**REED COLLEGE  
RESEARCH REACTOR  
LICENSE No. R-112  
DOCKET NO. 50-288**

**RESPONSES TO NRC  
REQUEST FOR ADDITIONAL INFORMATION  
AND CLARIFICATIONS TO THE  
SAFETY ANALYSIS REPORT**

RE: Clarifications to the Safety Analysis Report submitted in support of in the relicensing of the Reed Research Reactor - Response to phone calls on July 7, 2011 and July 15, 2011

## Reed Research Reactor Response

Figure 1 Power distribution for the RRR

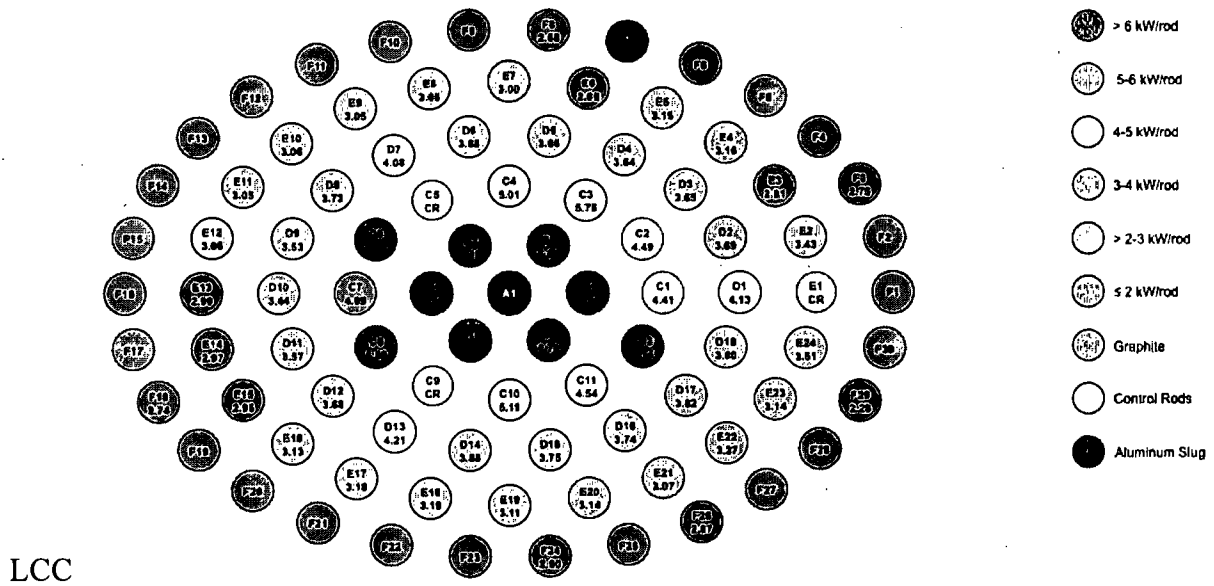
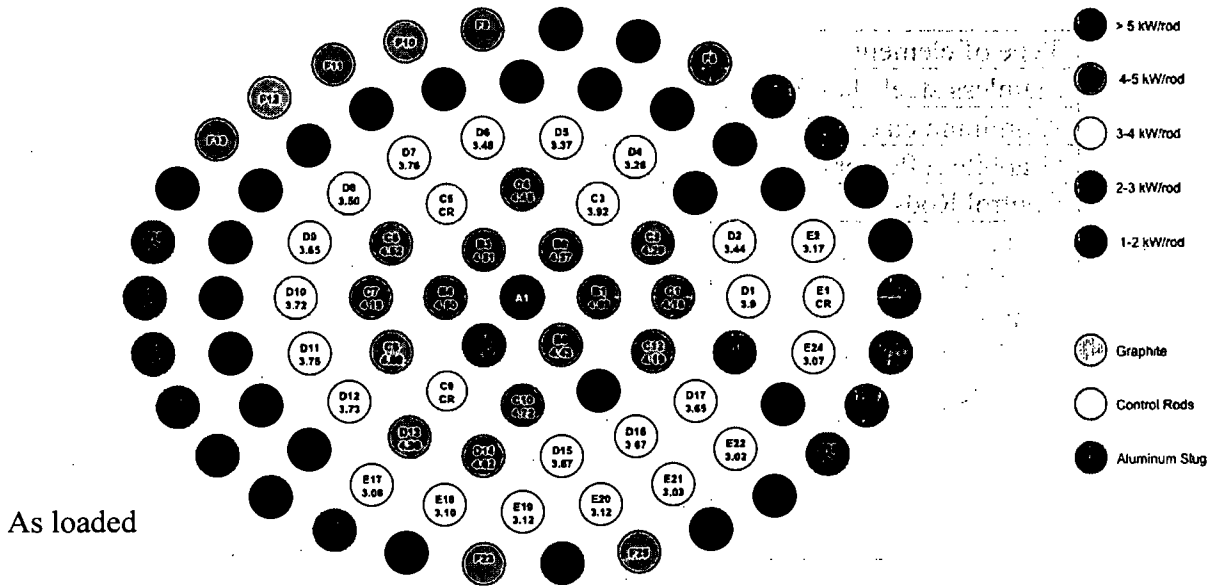
RAI 14. Please identify the Limiting Core Configuration as per NUREG 1537 and ANSI/ANSI 15.1.

The mixed clad fuel core analyzed in the aforementioned reports has since been replaced with an all stainless-steel clad fuel core. The neutronics for the all stainless-steel clad fueled core was evaluated using the same methodology as outlined in the report. Table 1 contains a summary of the core characteristics for comparison. The SS clad fuel was received as slightly irradiated fuel with an average of 3.8 MW-D on the fuel. This burn-up resulted in an increased number of fuel elements loaded into the core to achieve similar operational characteristics: core excess, shutdown margin and control rod worth. A second neutronic evaluation was completed for the stainless steel loaded core. The results of this analysis are included in Table 1. Although the core loading had changed from 64 to 79 elements, the hot channel identified remains in the same location. The higher burned stainless steel clad fuel has a lower power output per element as expected. The dominating parameter for determining the hot rod channel position is pitch. The core structure, upper grid and lower grid plates were visually inspected for wear and were determined to be usable for the requested license period. Since the pitch is the critical parameter and the all stainless steel core is slightly more burned, the fuel temperatures predicted for the mixed core are higher and has a higher maximum to average rod power output. The mixed core will be used as the limiting core configuration (LCC). The power distribution of the RRR for both core loadings are illustrated in Figure 1.

These analyses indicate that the parameters of the RRR core loaded in a close packed array of LEU fuel operated under the conditions as specified will have a hot rod channel power output less than the LCC which is 7.20 kW and a corresponding maximum centerline fuel temperature of 264 °C at 250 kW. The fuel temperature is significantly lower than the safety limit for stainless steel clad fuel of 1000 °C.
